Hi-Fi Products  
Service Bulletin

Model: STR-AV910/1010

No. 150

Subject: Missing Adjustment Procedures For Amp Bias Current      Date: December 10, 1990

(MAIN BOARD) (Conductor side)

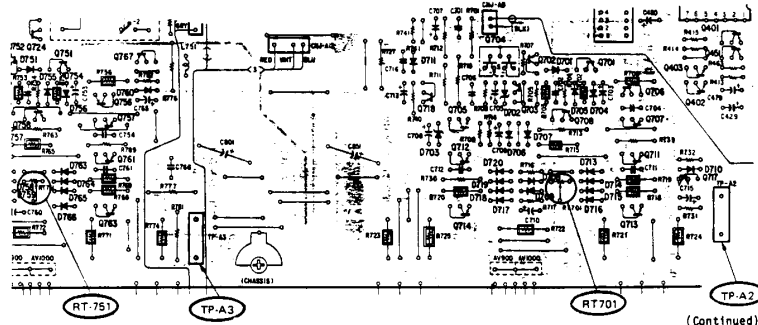
The adjustment procedures for the Amp Bias Current are not listed in the service manual.

Solution: Please update your service manual with the adjustment procedures listed below:

- Connect the digital voltmeter to Bias Check Point ( L : L-CH, R : R-CH)
- Increase the AC power voltage gradually to 120 V confirming that the voltmeter will not indicate an abnormal value.

- Confirm that the display is normal.
- Adjust RT701 (L-ch) or RT751 (R-ch) so that the reading on the voltmeter becomes 0.1 mV within 30 seconds after the power turned on.

- Turn the power off and remove the digital voltmeter.
